Access Compliance Report

Public Rights-of-Way

Intersection ID: 43273	Main Street: OLD_PROVIDENCE_RD	Cross Street: RED_BIRD_TL	Location: E
ADA ID: D027F8D6806A	Ramp Type: PerpDiag	Initial Pass/Fail: Fail	Overall Compliance: No
Severity Score: 13.75			
Codes/Mitigation Info/Possible Solution		Field Measurements/Component Compliance

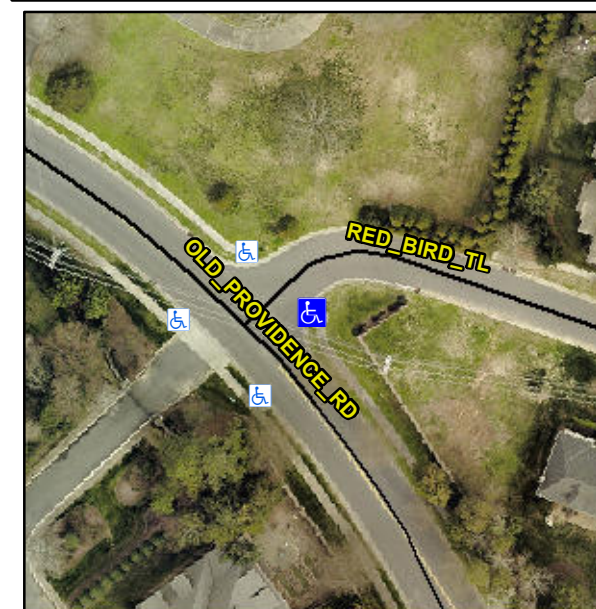
Not Found, R304.2.2, R304.5.3

Compliance	Description	Data	Compliance	Description	Data
N/A	Ramp Length (in)	110.0	No	Ramp Slope (%)	8.8
Yes	Ramp Width (in)	48.0	No	Ramp XSlope (%)	2.8
N/A	Flare Type LT	N/A	N/A	Flare Type RT	N/A
N/A	Flare Slope LT (%)	N/A	N/A	Flare Slope RT (%)	N/A
N/A	Flare Traversable LT?	N/A	N/A	Flare Traversable RT?	N/A
N/A	Landing Length (in)	N/A	N/A	DWS Provided?	N/A
N/A	Landing Width (in)	N/A	N/A	DWS Contrast?	N/A
N/A	Landing Slope (%)	N/A	N/A	DWS Length (in)	N/A
N/A	Landing X Slope (%)	N/A	N/A	DWS Full Width?	N/A
N/A	Landing Curb? (Y/N)	N/A	N/A	DWS Offset (in)	N/A
N/A	Shared Landing?	N/A			
N/A	Gutter Ponding?	N/A	N/A	Gutter Slope (%)	N/A
N/A	Gutter Lip Ht (in)	N/A	N/A	Gutter X Slope (%)	N/A
N/A	Painted X Walk1?	No	N/A	Painted X Walk2?	No
	X Walk 1 Direction	To NW		X Walk 2 Direction	To SW
N/A	X Walk 1 Width (in)	N/A	N/A	X Walk 2 Width (in)	N/A
	X Walk 1 Slope (%)	2.3		X Walk 2 Slope (%)	0.8
	X Walk 1 X Slope (%)	0.8		X Walk 2 X Slope (%)	3.0

Remove & Replace Curb Ramp With Two New Directional Ramps or Equivalent.
